**Environmental impact assessment  
for the life extension and upgrading  
thermal power of Olkiluoto units 1 & 2**

**Project element: scoping**

**Project Manager** Franz Meister (Umweltbundesamt)

**Authors** Bojan Tomic (Enconet Consulting Ges.m.b.H.)  
Ioana Popa (Enconet Consulting Ges.m.b.H.)  
Oana Velicu (Enconet Consulting Ges.m.b.H.)

Figure 2:  
Alternatives examined in  
the EIA procedure and  
their preliminary  
planned schedule

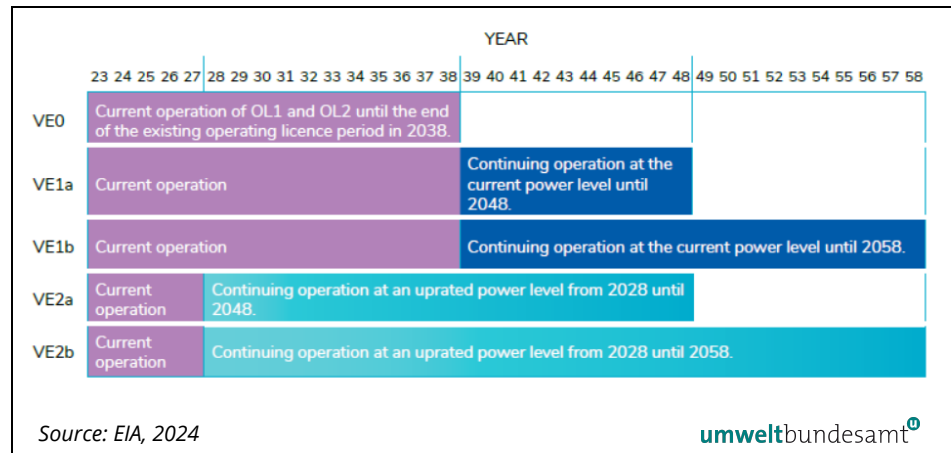
While the concept for different alternatives are clearly described and graphically depicted in a very clear and understandable way (as represented in the Graphic No. 2), the EIA programme document provides very little information in relation to what each of the alternatives would entail in the terms of technical requirements, eventually needed modernisation, improvements or changes of the design or the acceptance of the regulator.

1. For each of the alternative, the EIA report shall provide the detailed discussion on the technical basis, the safety assessment, the impact assessments as well as the basis and criteria that is being used to evaluate the alternatives that are being considered
2. Alternatives like new NPPs or non-nuclear electricity sources are also to be considered as an option
